BAKERS HOUSE

25 Bakers Road, Uxbridge, UB81JY

15th November 2019

This Addendum Design Statement describes in detail all the architectural changes made.

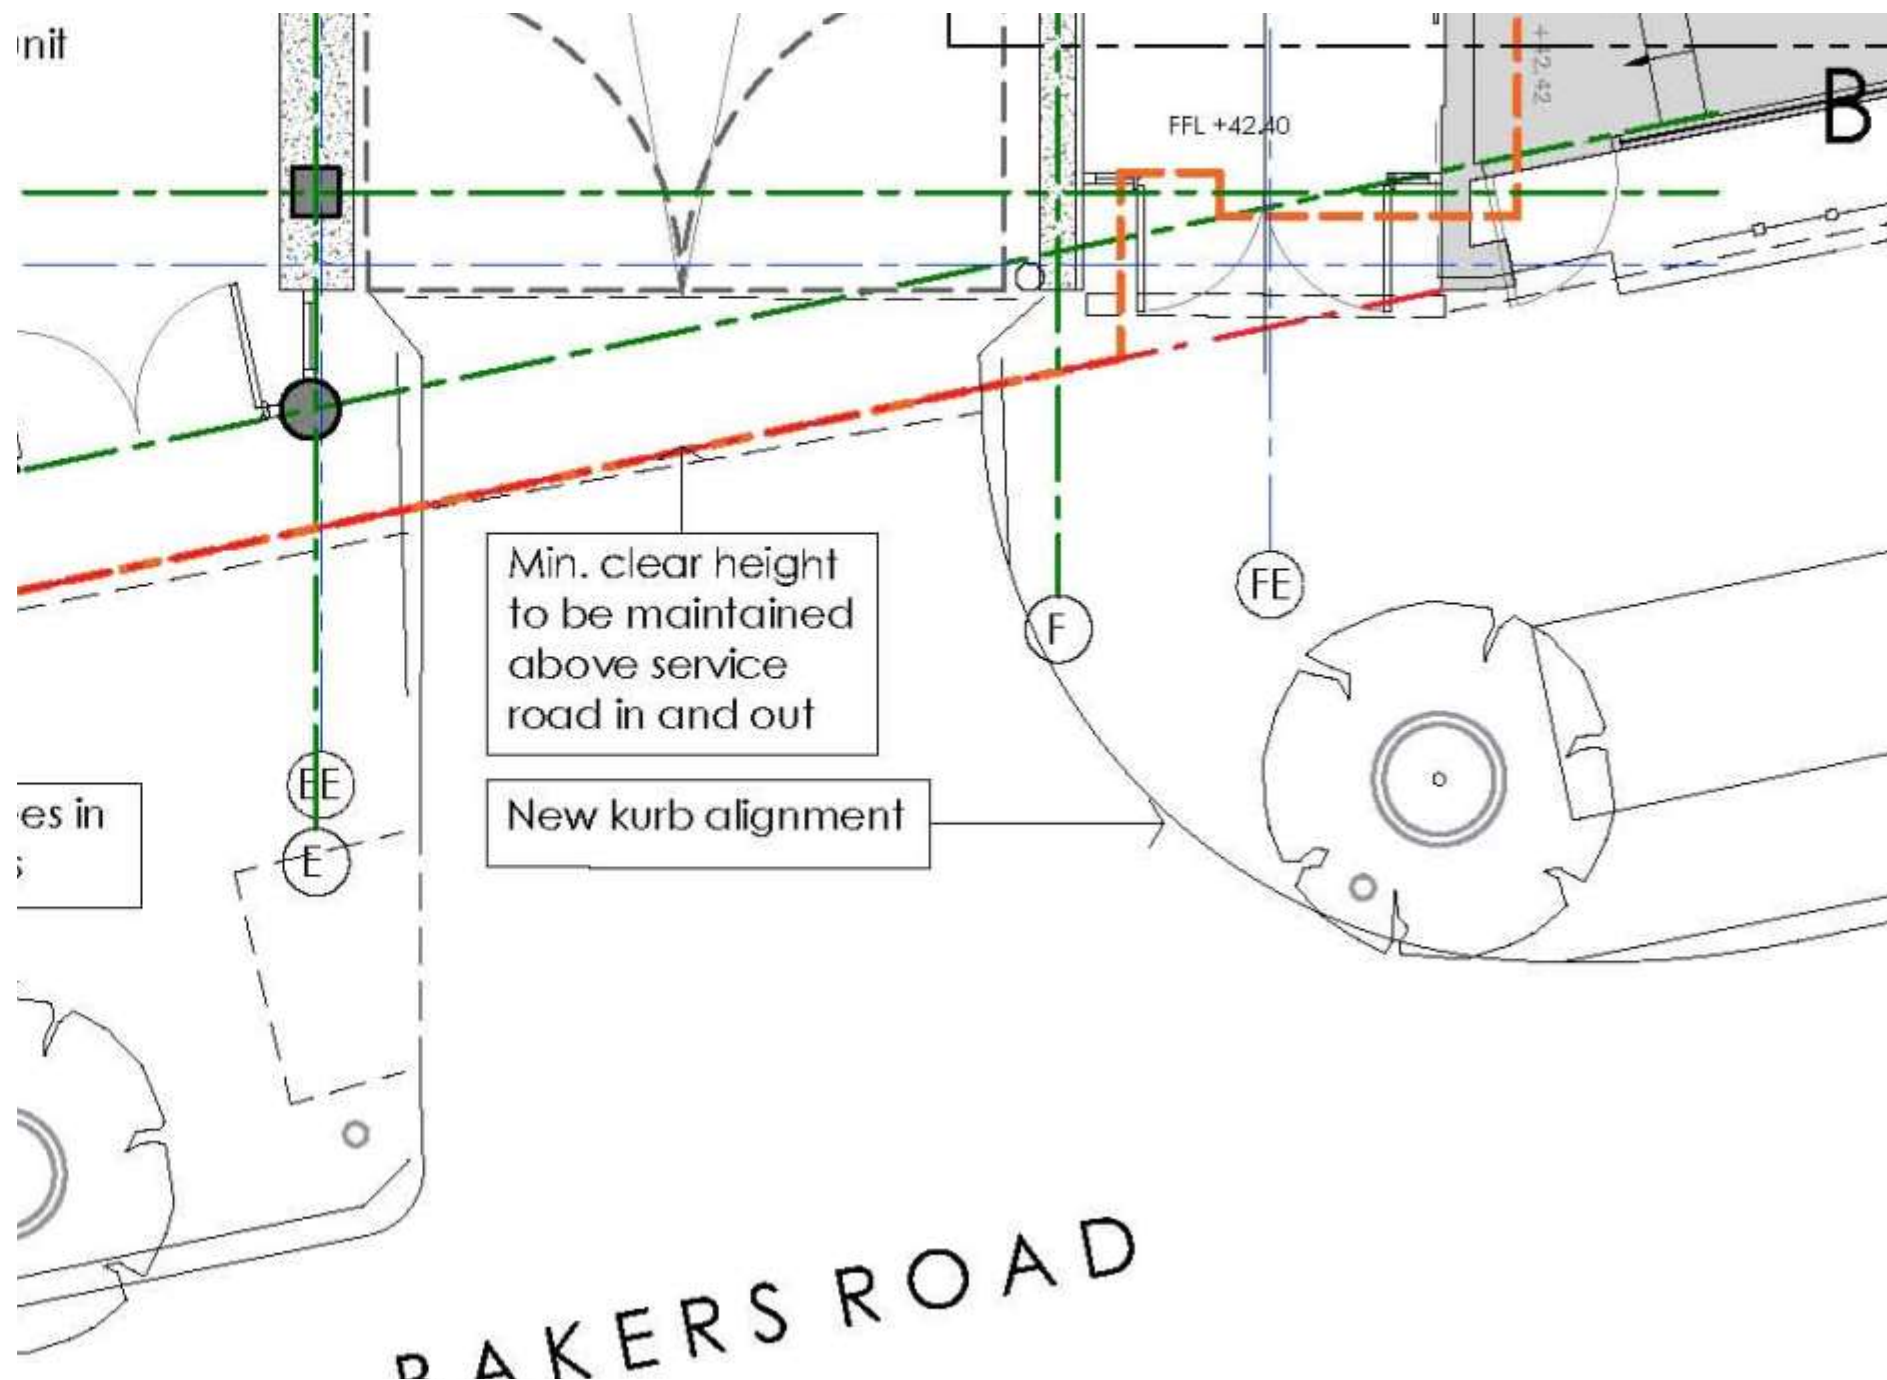
The kerb on Bakers Road has been altered to ease the path of vehicles leaving the site.

The revised scheme eases the kerb line at the exit point from the ground floor service yard, to meet comments raised by Hillingdon's highways engineers.

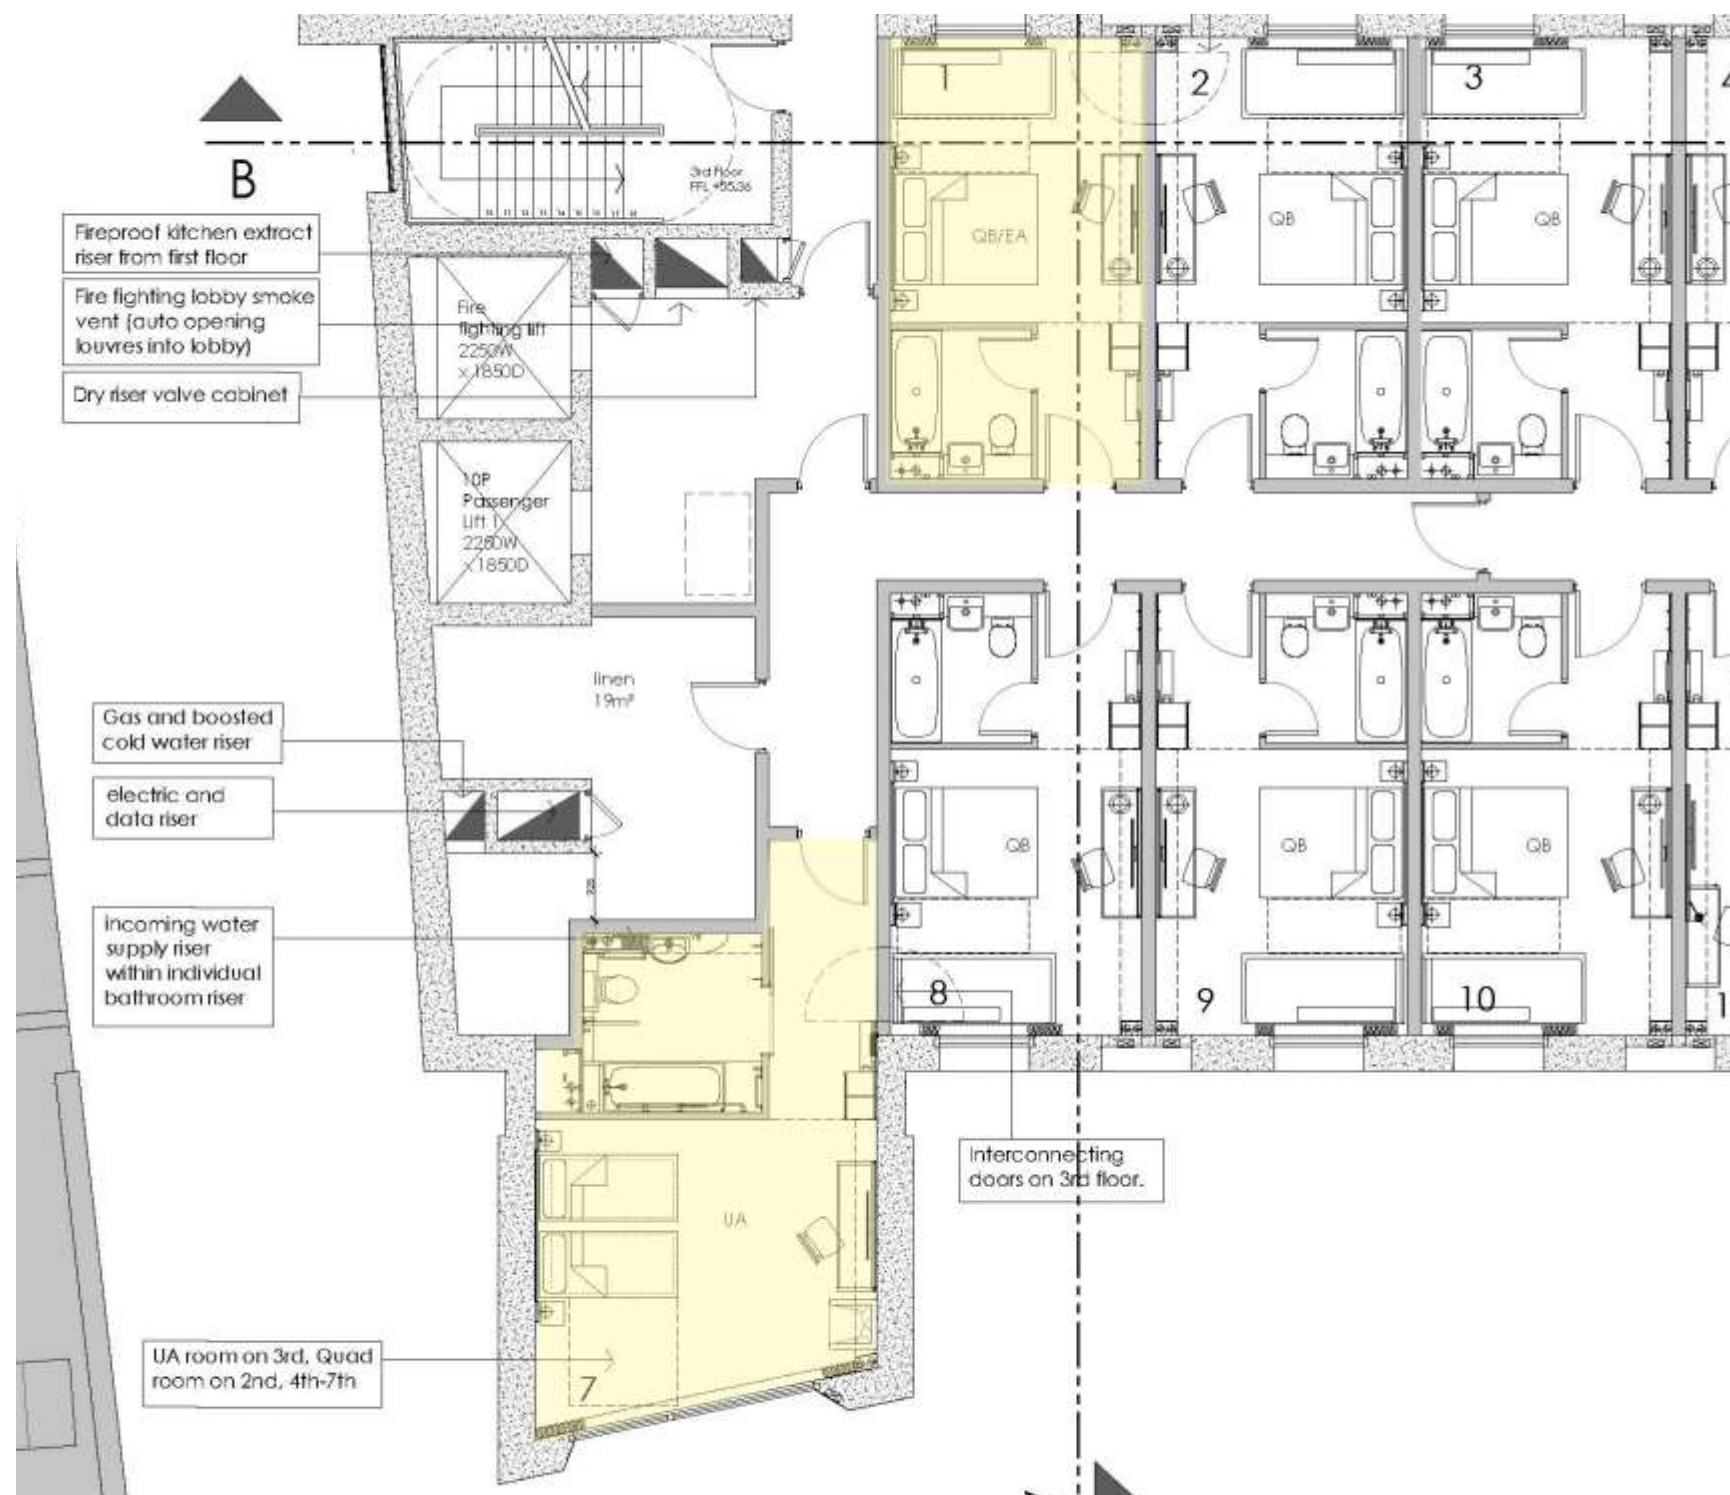
Changes have also been made at basement level, where an additional disabled parking space has been added (space number 9) in lieu of two existing standard spaces (originally numbers 10 and 11), and the proposed hotel parking has been adjusted to provide 2 alternative standard spaces for the hotel elsewhere in lieu of those lost.

Revised typical upper floor

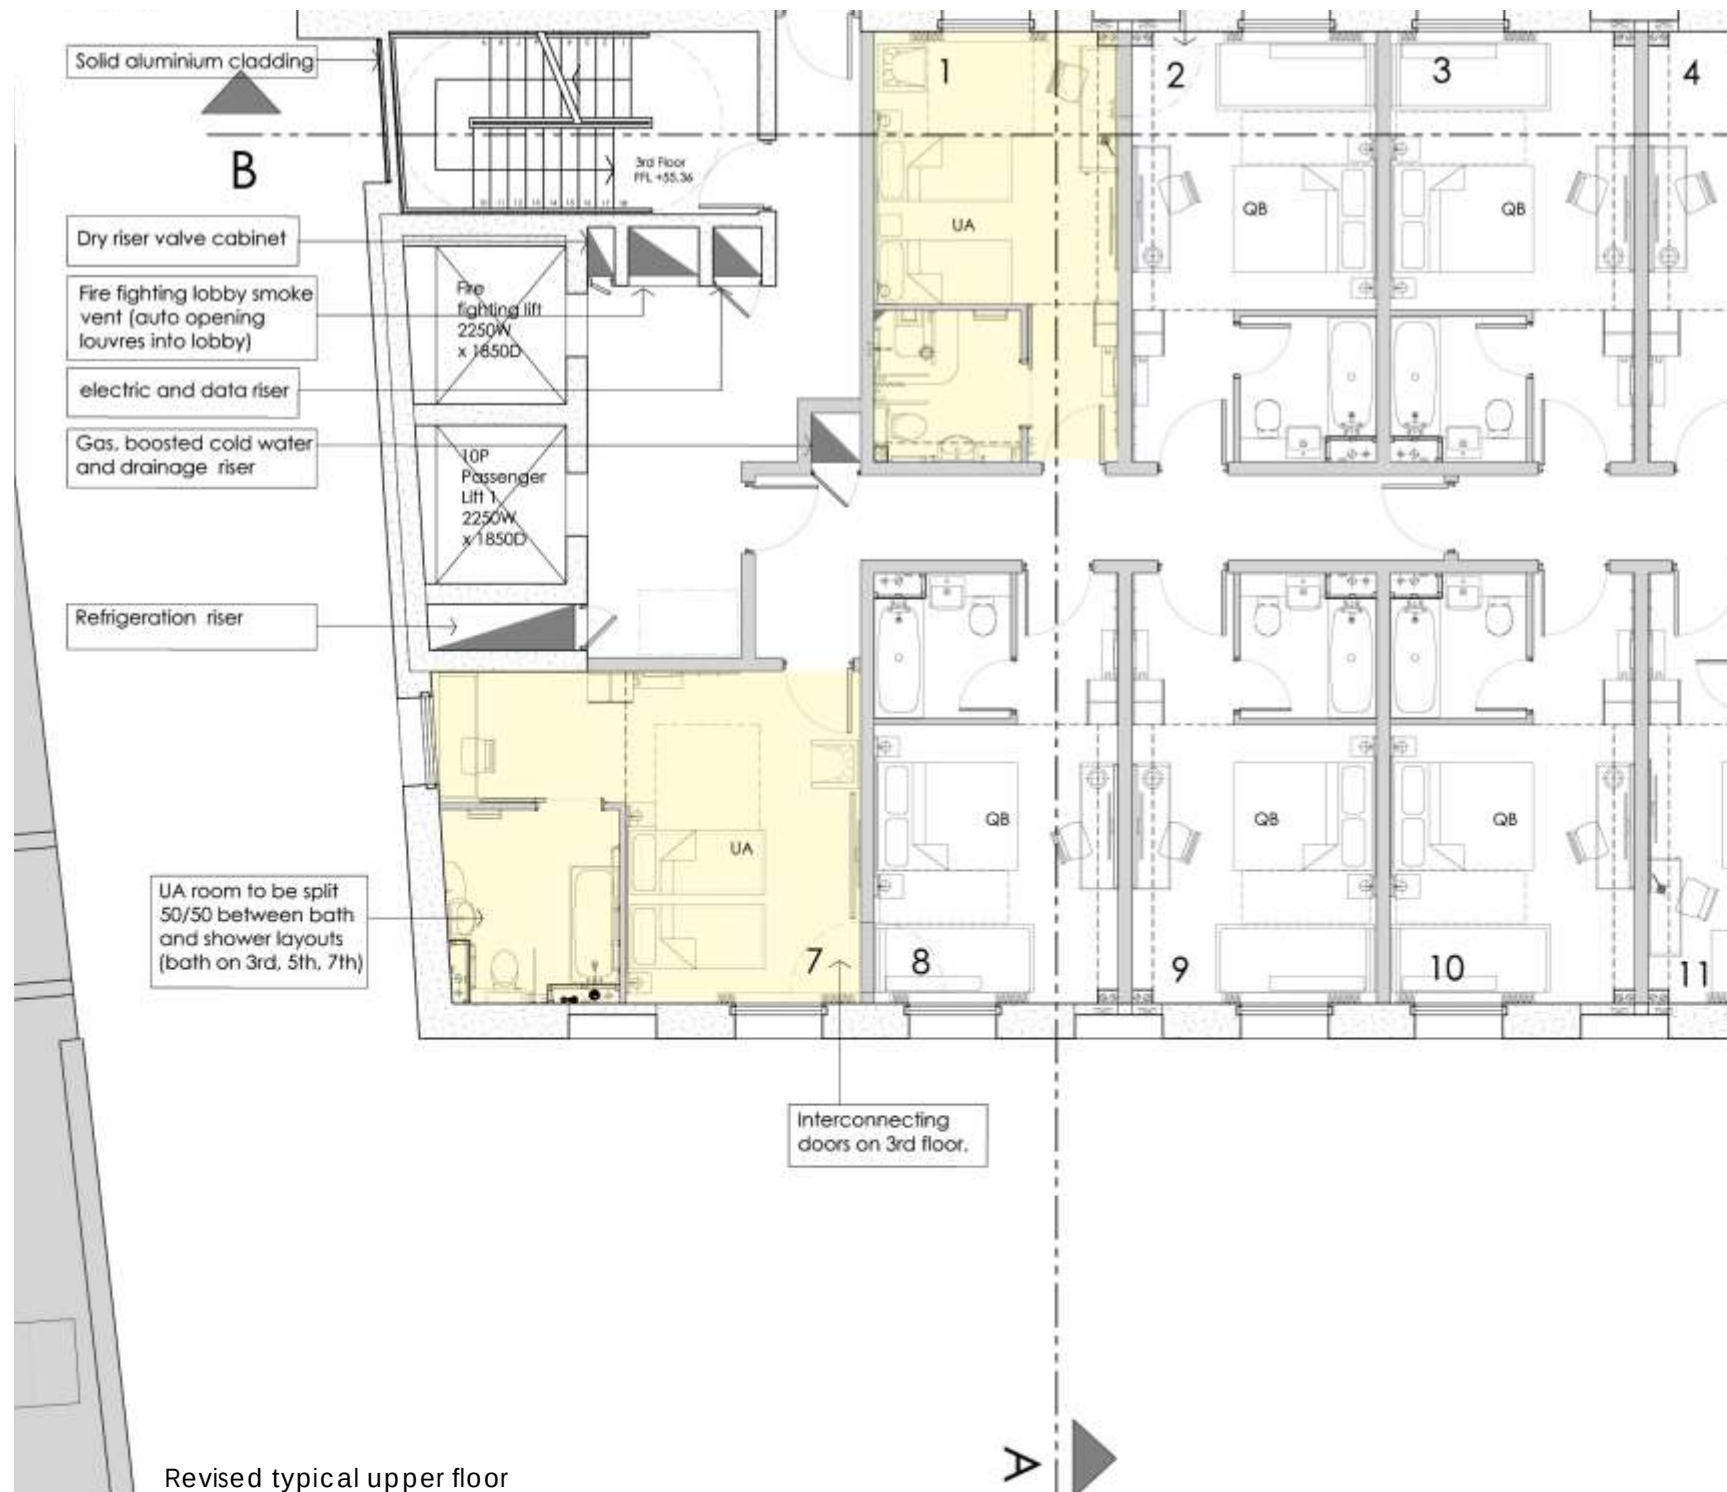
10% of all rooms in the revised scheme will be wheelchair accessible.

The application scheme was probably confusing, since it labelled 5% of the rooms as 'EA' types – which is the notation applied to those rooms that are capable of easy conversion to wheelchair accessible types.

We have now adjusted the proposals so that the 'EA' type is removed and replaced with 'UA' type rooms, denoting full accessibility. There are 14 of these rooms in the scheme, i.e. 10%.
